SUNDRY NOTICES AND REPORTS ON WELLS
Do not use this form for proposals to drill or to re-enter an abandoned well. Use form 3160-3 (APD) for such proposals.

8. Well Name and No.
P L DAVIS 2E

Re: Permanent Abandonment
Well: PL Davis 2E

CONDITIONS OF APPROVAL

Proposed Well Schematic for Plug and Abandon

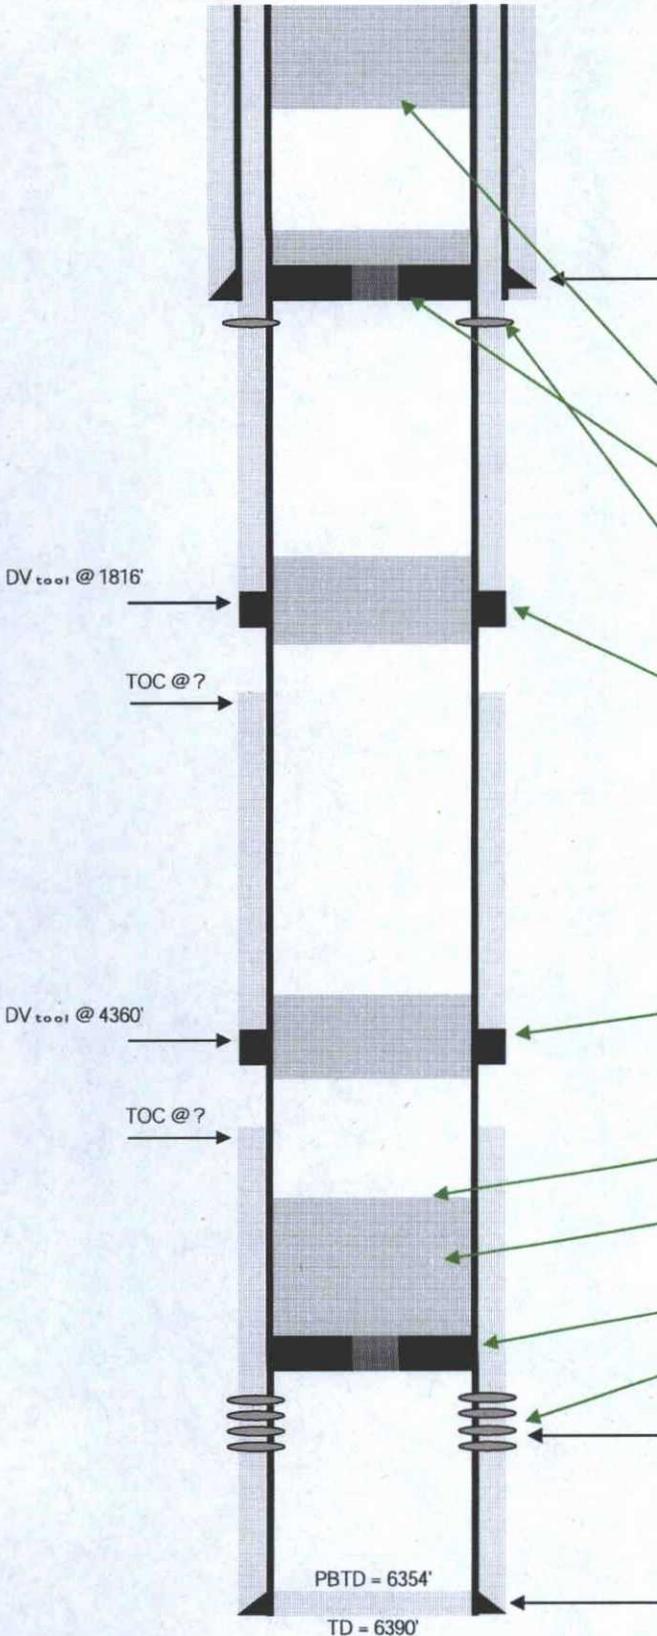
3. The following modifications to your plugging program are to be made:

- a) Set plug #3 (2527-2427) ft. to cover the Cliff House top. BLM picks top of Cliff House at 2477 ft.
- b) Set a cement plug (1670-1570) ft. to cover the Pictured Cliffs top. BLM picks top of Pictured Cliffs at 1620 ft.
- c) Set a cement plug (1394-1294) ft. to cover the Fruitland top. BLM picks top of Fruitland at 1344 ft.
- d) Set a cement plug (744-531) ft. to cover the Kirtland and Ojo Alamo tops. BLM picks top of Ojo Alamo at 581 ft. BLM picks top of Kirtland at 694 ft.

Run CBL from 6064 ft. to surface to verify cement top. Submit the electronic copy of the log for verification to the following addresses: jwsavage@blm.gov tsalyers@blm.gov
Brandon.Powell@state.nm.us
